S16YN

Subject: S16YN
Rear Air Disc Brake Axle Shaft Flange Nut Replacement

Models Affected: Model Year: Certain 2015-2017
Model: Vision and All American
School Bus and Non-School Bus

Rear Air Disc Brake Axle Shaft Flange Nut Replacement

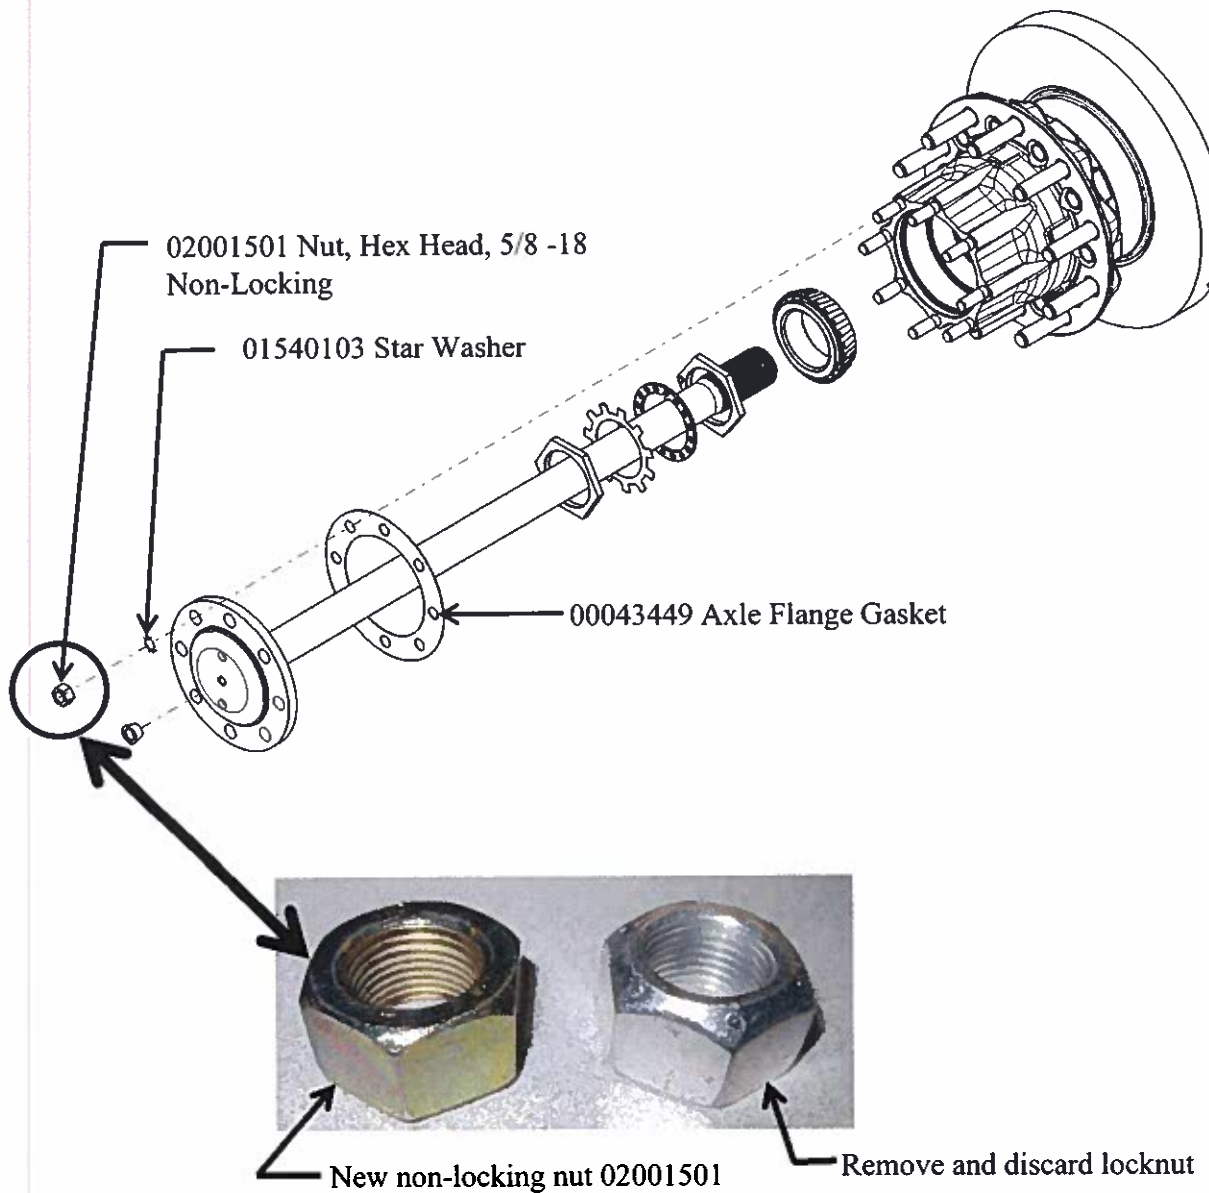
Rear axle shaft flange nut torque reduces allowing for oil leak between the axle shaft and hub.

Replace the existing rear axle flange lock nut with a new non-locking nut and star washer. Request that the Service Manual be updated by technician to show new nut and torque.

1. Park bus on level surface, turn off engine, remove ignition key, and chock wheels.
2. To reduce the possibility of the stud being removed when removing locknut, remove the paint from the existing rear axle shaft flange studs.
3. Remove and discard the first lock nut and star washer.
4. Replace the hardware in Step 3 with a new star washer 01540103 and a new non locking nut 02001501.
5. Torque nut to 60-70 ft-lb.
6. If a stud comes out during removal of locknut, remove the locknut from the stud and reinstall the stud into the hub. Torque stud to 60 to 70 ft-lb.
7. Remove the next lock nut and star washer in a "star" pattern.
8. Repeat Steps 3 to 6 until all eight star washers and lock nuts are replaced.
9. Re-torque all nuts to 170-180 ft-lb. in a "star" pattern.

NOTE 1: If there is a leak at the rear axle flange gasket, remove and discard all eight locknuts and star washers. Replace gasket, install axle shaft, and install eight new star washers 01540103 and new non-locking nuts 02001501. Torque all eight nuts per Step 9 above.
